1. JOHN ARTHUR BLESSIN, NMPE 13481- OF THE FIRM CLAUDIO VIGIL ARCHITECTS, HEREBY CERTIFY THIS PROJECT HAS BEEN GRADED AND WILL DRAIN IN SUBSTANTIAL COMPLIANCE WITH AND IN ACCORDANCE WITH THE DESIGN INTENT OF THE APPROVED PLAN DATED 3/77/01- THE RECORD DRAWING. I HAVE CONDUCTED A VISUAL DESIGN VERIFICATION AND HAVE BEEN INFORMED BY ME OR UNDER MY DIRECT SUPERVISION AND IS TRUE, AND IS CORRECT TO THE BEST OF MY KNOWLEDGE AND BELIEF. THIS CERTIFICATION IS SUBMITTED IN SUPPORT OF A REQUEST FOR PERMANENT CERTIFICATE OF OCCUPANCY.

GRADING AND DRAINAGE PLAN - LOT 13

MERIDIAN LOT 13
NEW OFFICE WAREHOUSE
7300 MERIDIAN PLACE, NW
ALBUQUERQUE, NEW MEXICO

C-1

GRADING AND DRAINAGE PLAN

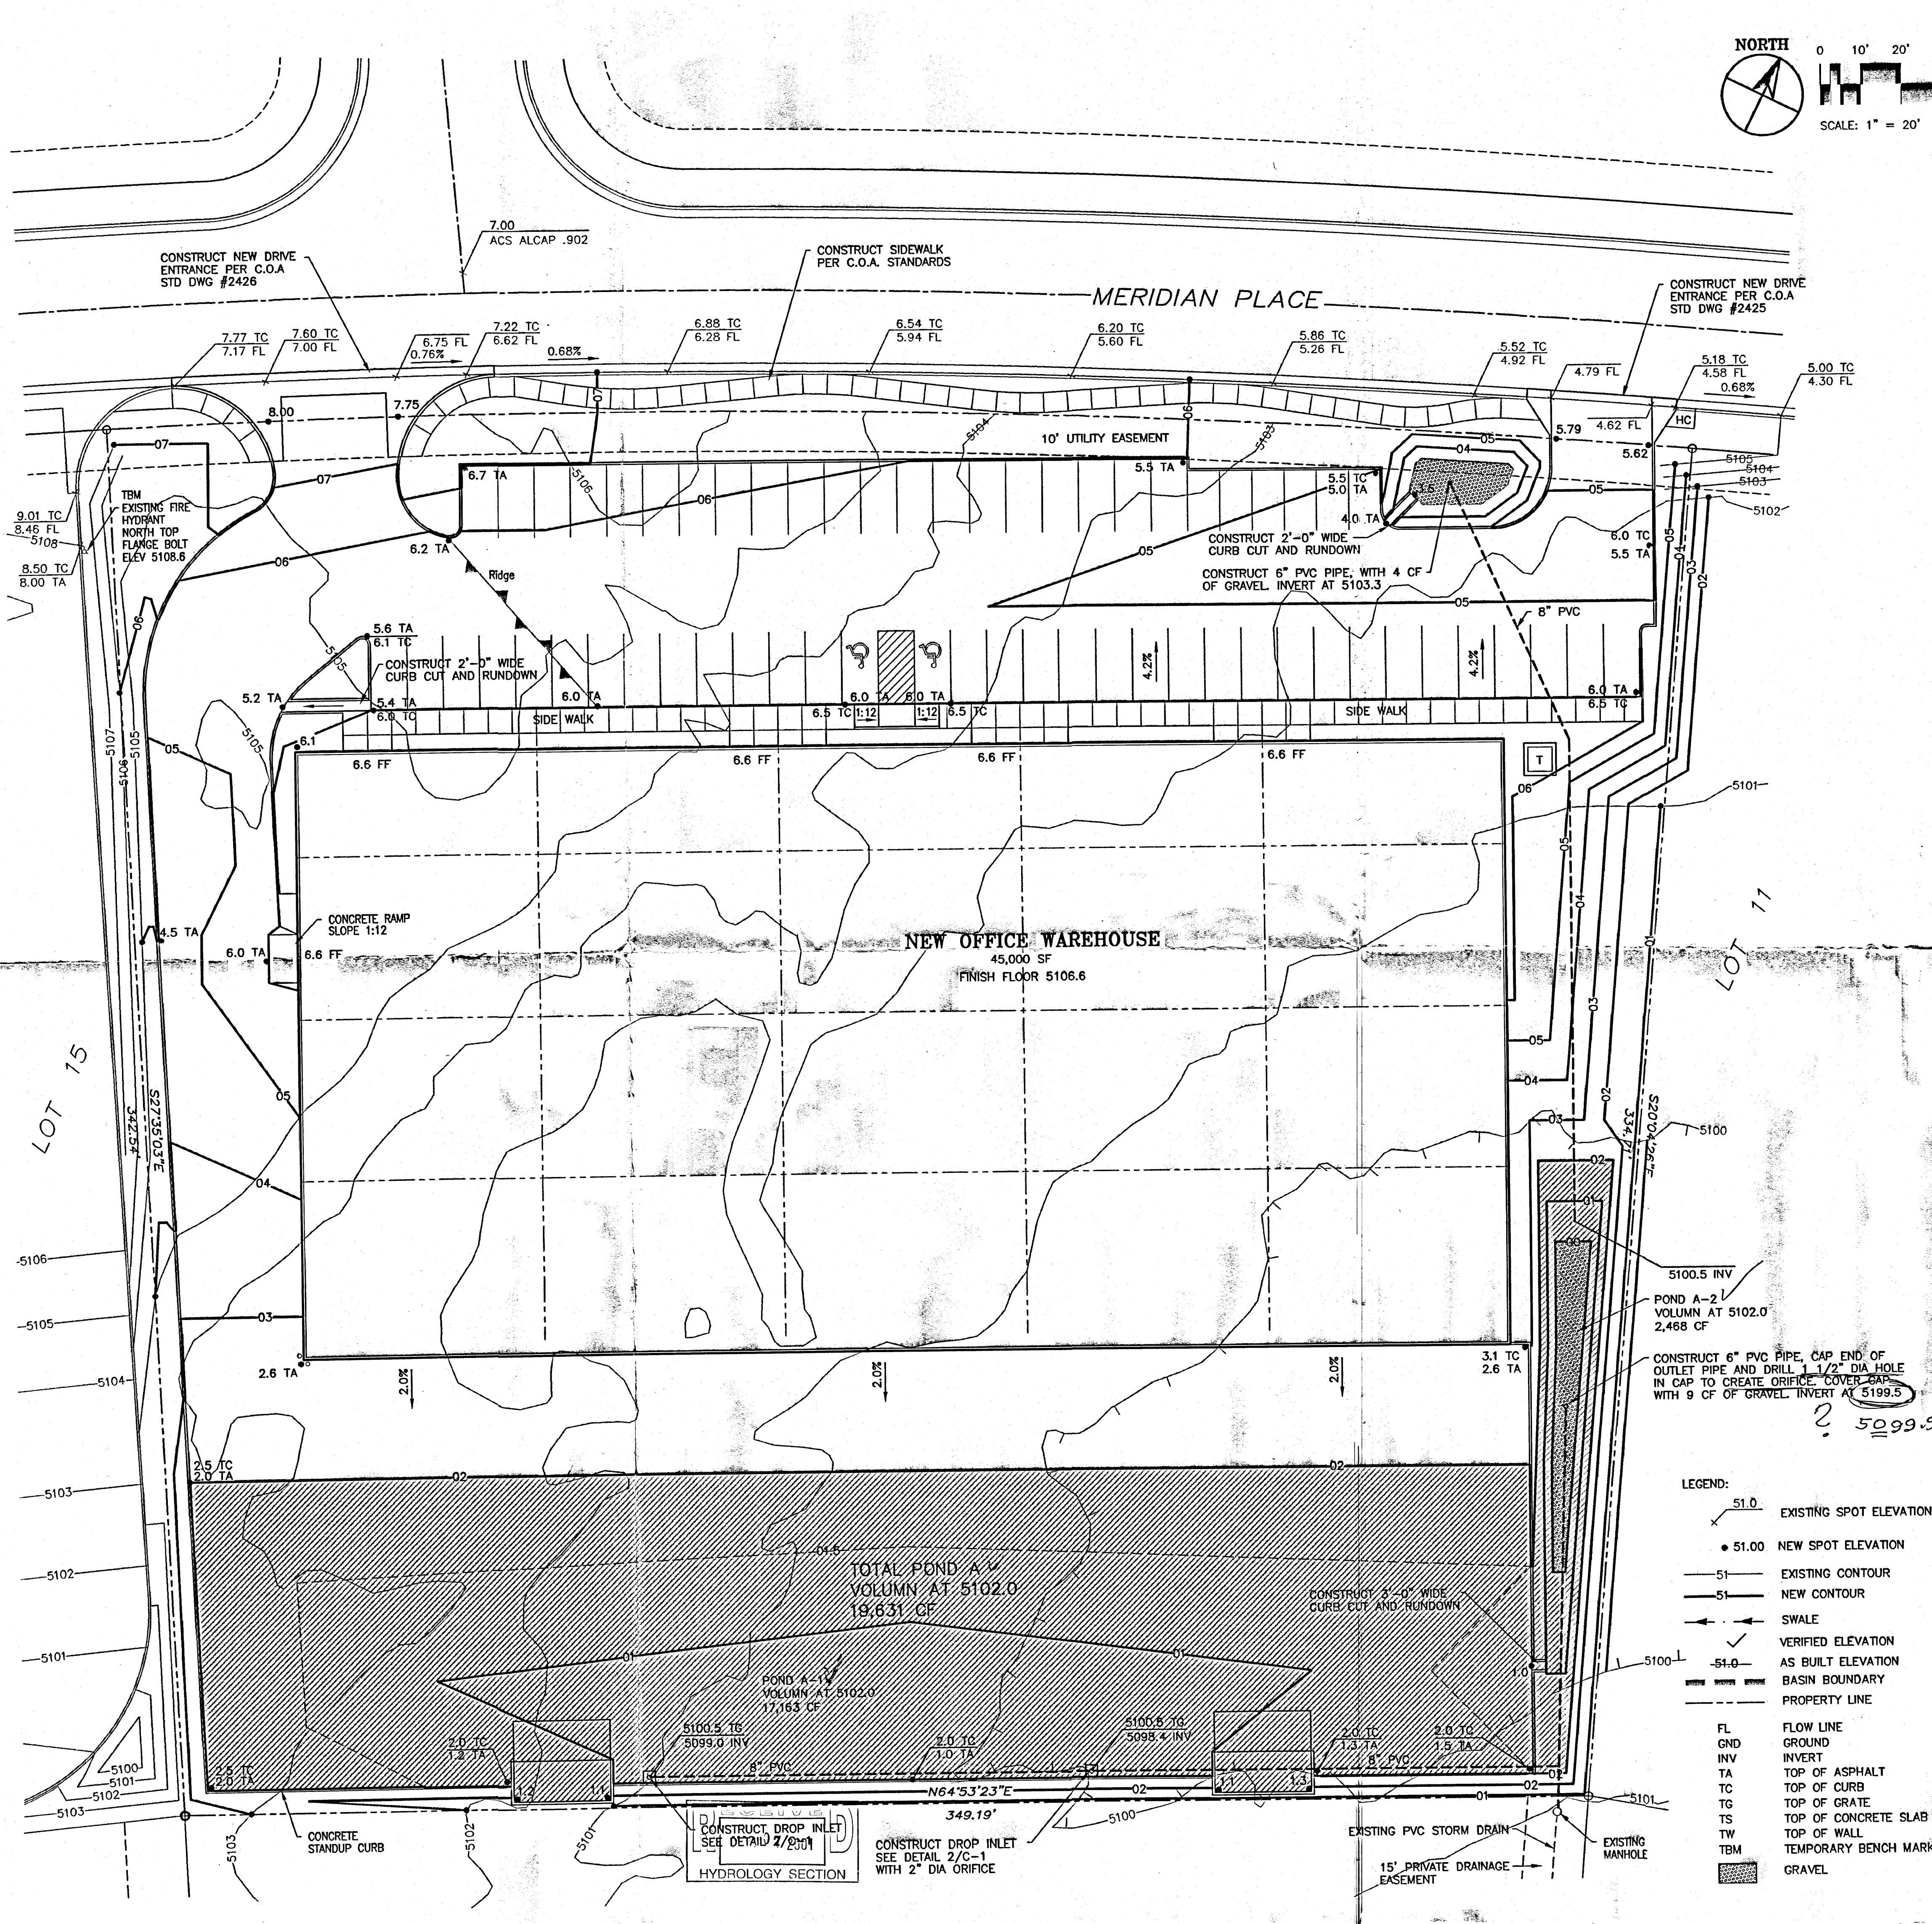
THE CURB ALONG THE SOUTH PROPERTY LINE AND TRASH ENCLOSURES HAVE NOT BEEN INSTALLED PENDING APPROVAL OF BY DBP OF LOT 14.

NEW OFFICE WAREHOUSE
45,000 SF
✓ FINISH FLOOR ~~5106.6~~
5106.43

✓
CONSTRUCT 6" PVC PIPE, CAP END OF
OUTLET PIPE AND DRILL 1 1/2" DIA HOLE
IN CAP TO CREATE ORIFICE. COVER CAP
WITH 9 CF OF GRAVEL. INVERT AT ~~5199.5~~
5099.9
